RALPH G. MASTROMONACO, P.E., P.C.

Re: Wael Alesawy Subdivision – 32 Orchard Drive
Armonk, NY

We received comments from John Kellard, PE dated April 20, 2023 updated September 8, 2023, and we offer the following information:

We received a Staff Report from the Town of North Castle Planning Department dated August 9, 2023 for Meeting Date September 11, 2023, and we offer the following information:

Figure: Profile showing extent of additional excavation along the roadway if the Private Road Standards are applied.

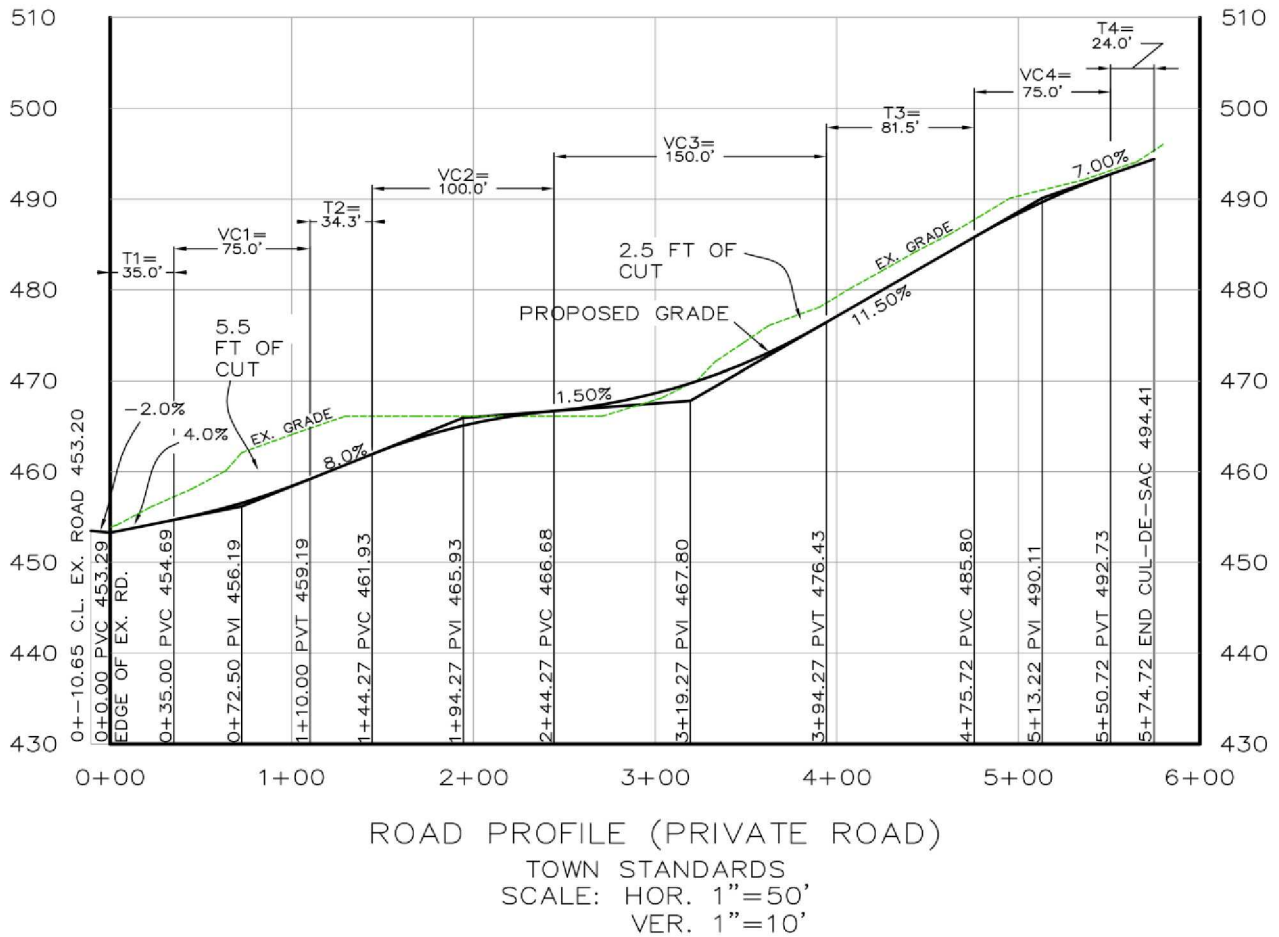
The revised roadway represents a much improved design which complies with all aspects of the Town’s private roadway standards, except the entry grade and Vertical Curve #1. The maximum entry grade of 4% must extend 10 feet beyond the right-of-way boundary or 35 feet of roadway centerline, whichever is greater. The minimum vertical curve should be 75 feet

Response: We are requesting minor relief from the PB to allow the private roadway as shown. For discussion, we attach a profile showing a conforming road profile that necessitates excavation for nearly the entire roadway that would be eliminated with the requested relief. The applicant’s preferred roadway follows an existing driveway and the hope is to minimize construction for this minor roadway.

ALTERNATE
PRELIMINARY PLAT
PROPOSED SUBDIVISION
AT
32 ORCHARD DRIVE
TOWN OF NORTH CASTLE
WESTCHESTER COUNTY, NY
SEPTEMBER 21, 2023
SHEET 1 OF 1 SHEETS

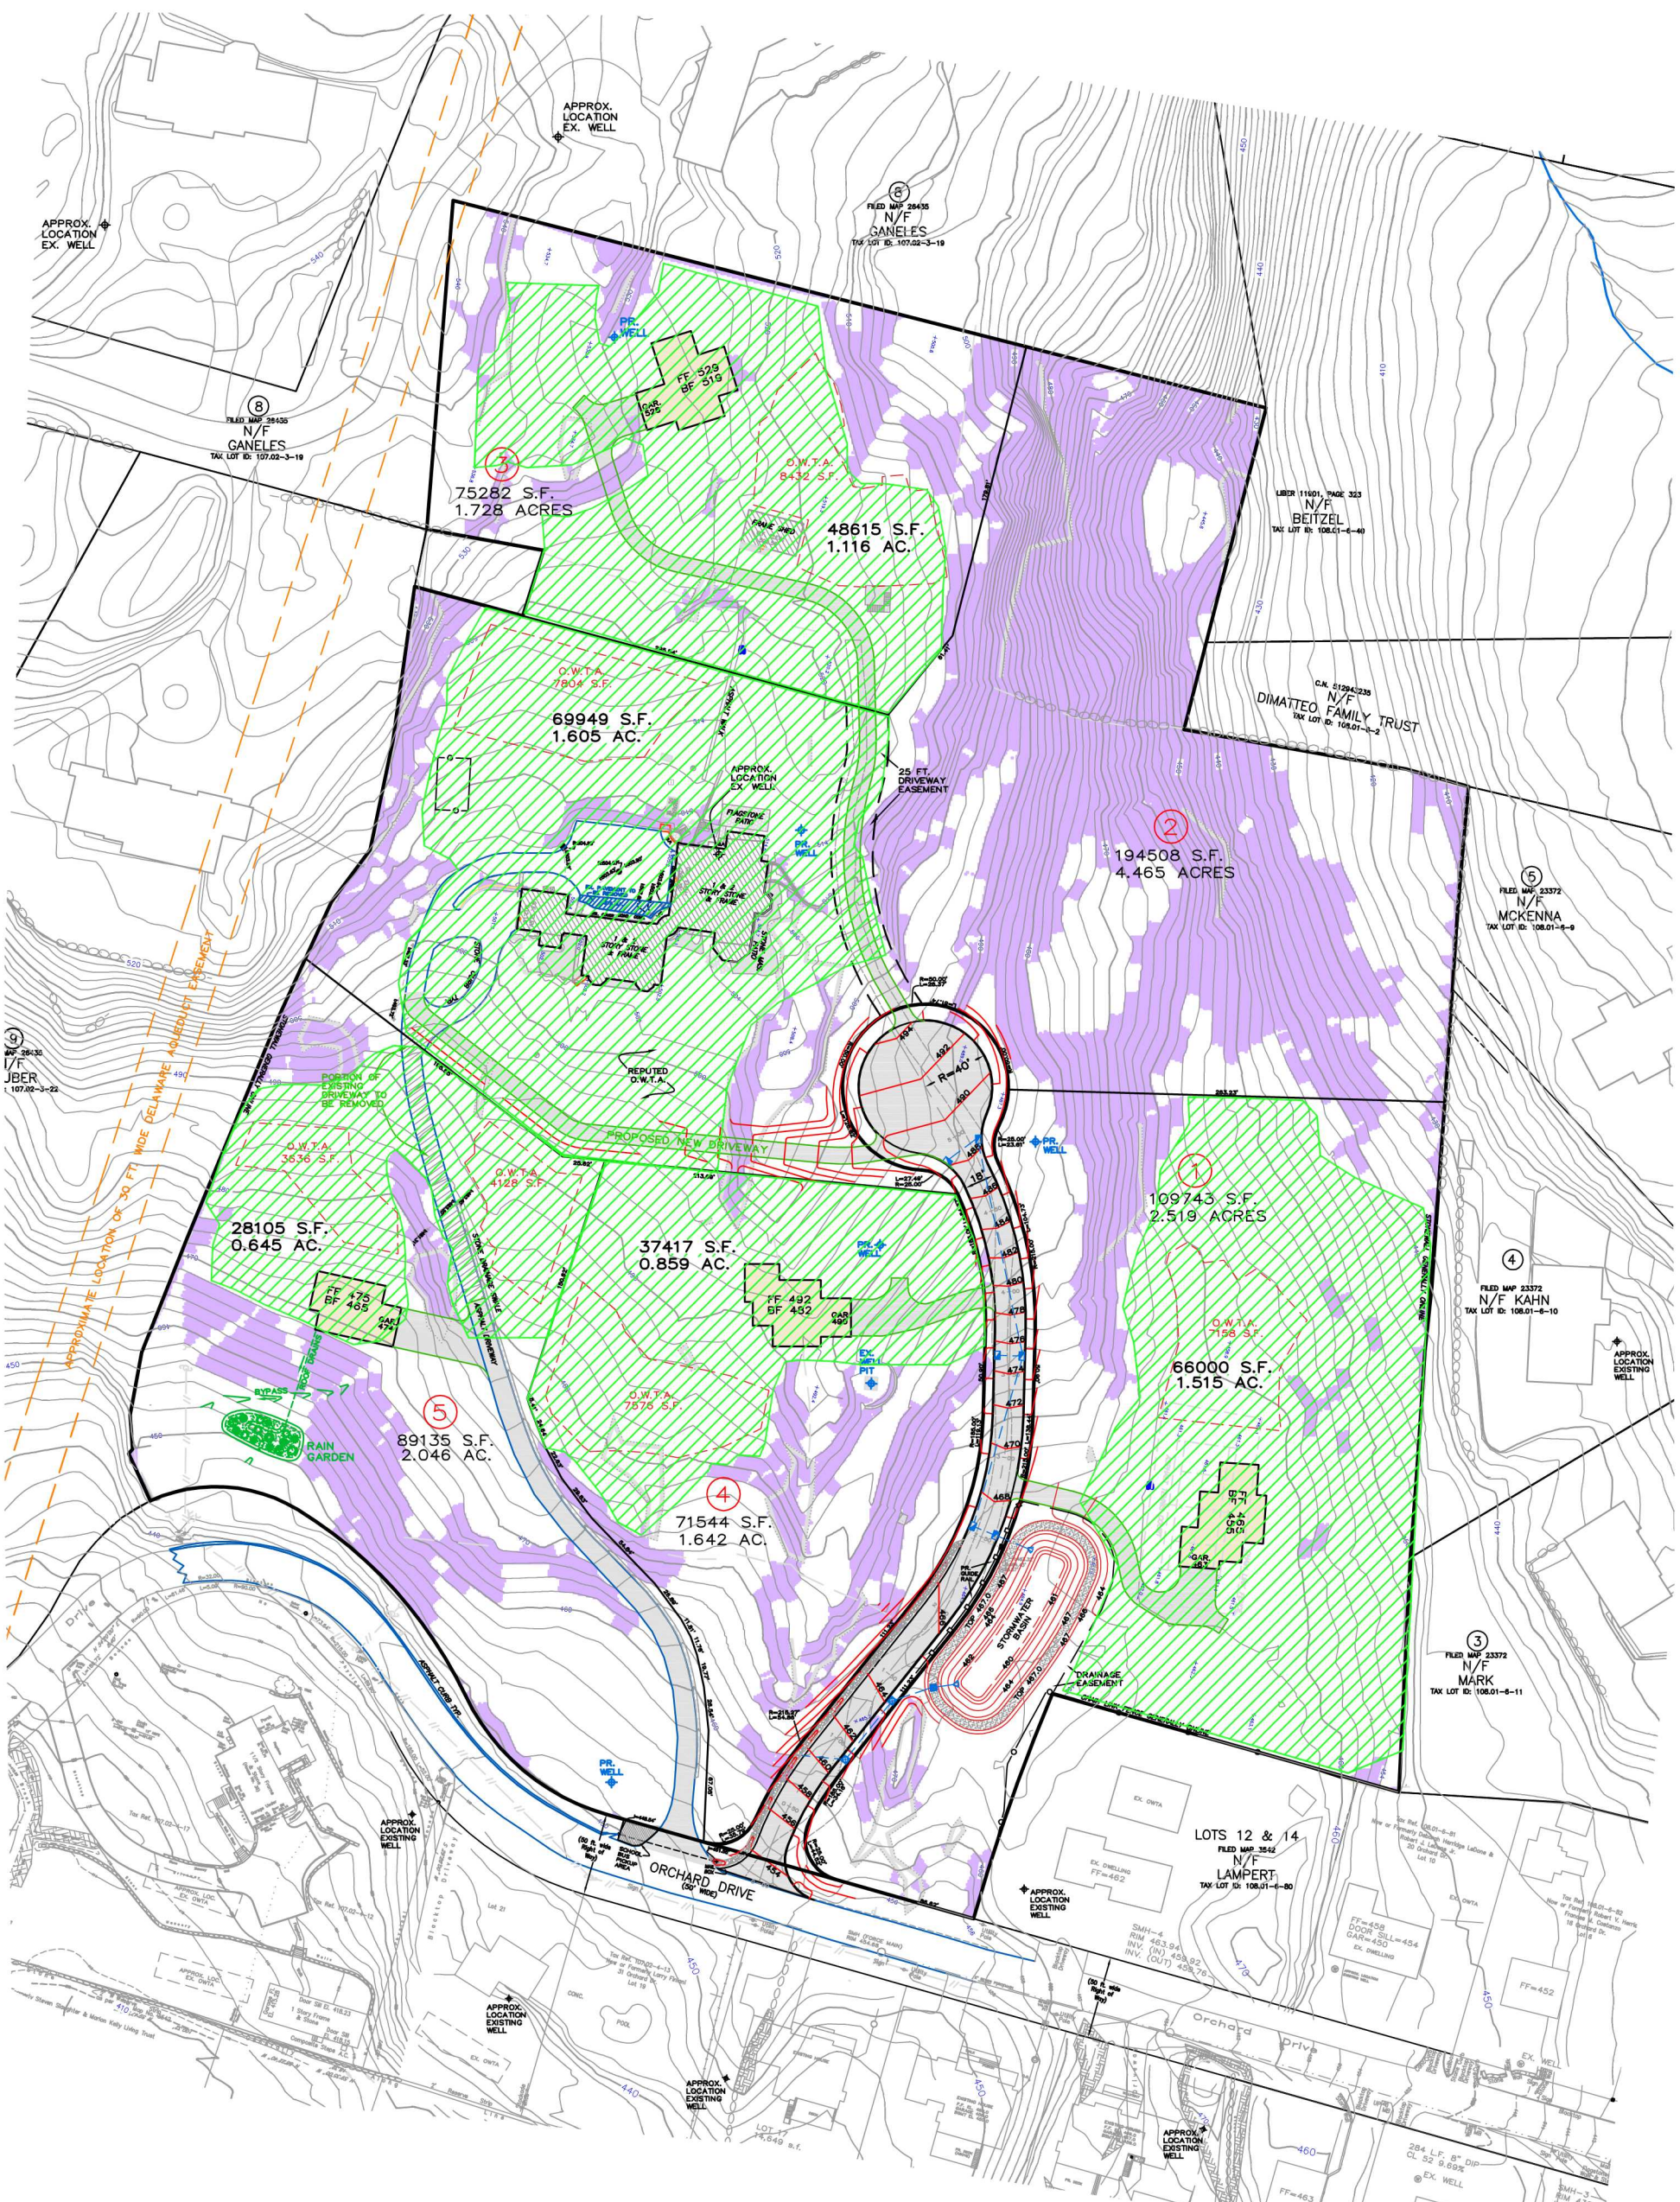
(Comment cont'd) The Alternate Plan provides an irregular shaped access strip for Lot #3, which is 15 feet wide and 900+ feet long around Lot #2 in an effort to establish frontage on the private roadway. The lot is not accessible through this access strip. Furthermore, when evaluating conformance to the Bulk Zoning Requirements for the District, a lot with a total depth of 1,200+ feet would need to be at least 150,000 s.f. (3.44 acres) in size to conform to the width requirements (125 feet) of the District. The applicant should reevaluate zoning compliance of Lot #3.

Response: The Town Code allows the median line to be drawn from the frontage to the rear property line. The rear property line is defined as opposite to the frontage. Accordingly we show that the average lot width is proper when the median line is drawn along the flag to the rear property line as defined in the Code. In any case, if the PB prefers we would apply for a 280-A variance.

Further, since the Town defines frontage from a “Way”, our median line could be drawn from Stony Brook “Way” to the rear property line and still be conforming as to average lot width. All of these computations of Average Lot Width are provided on the attached exhibit.

CONTIGUOUS BUILDABLE AREA/
 SLOPE MAP
 PROPOSED SUBDIVISION
 AT
 32 ORCHARD DRIVE
 TOWN OF NORTH CASTLE
 WESTCHESTER COUNTY, NY
 SEPTEMBER 21, 2023

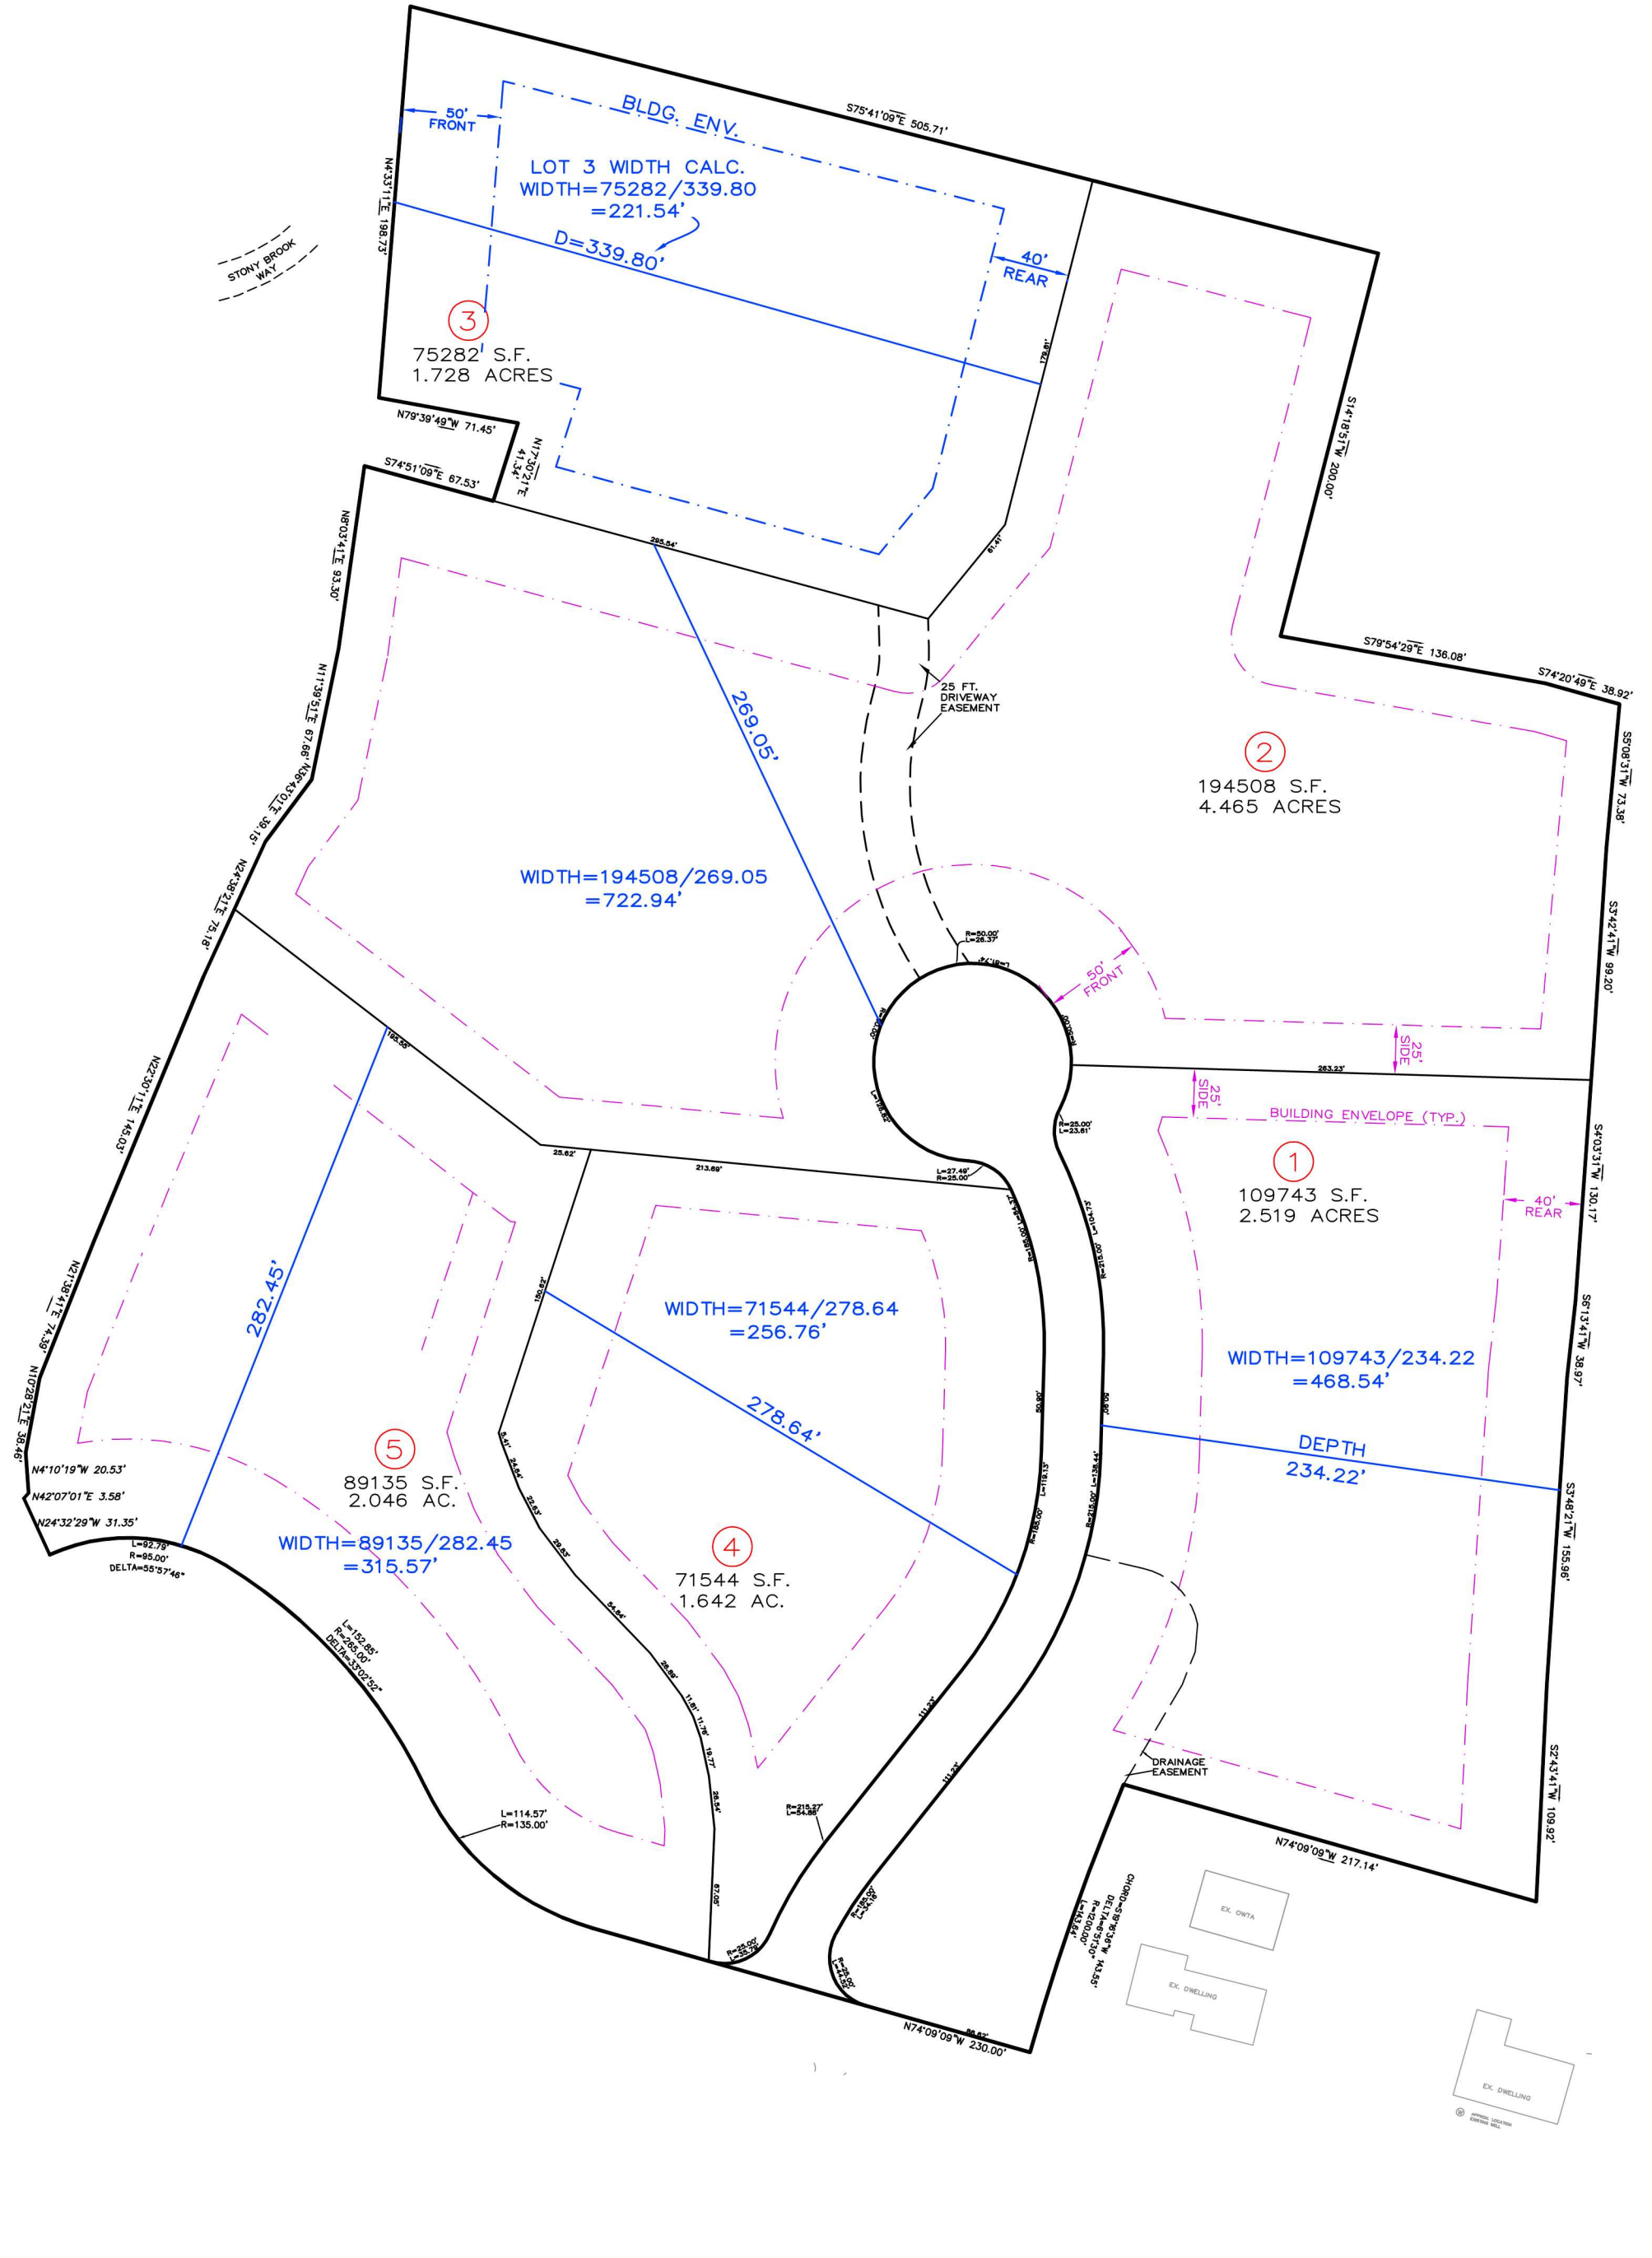
The property contains Town-regulated steep slopes. The Applicant should submit a plan that depicts the location of all Town-regulated steep slopes and depicts proposed Town-regulated steep slope disturbance. In addition, the plan should quantify, in square feet, the proposed amount of Town-regulated steep slope disturbance.

Response: We provided slope maps and a variety of computations in regard to lot and gross lot coverage.
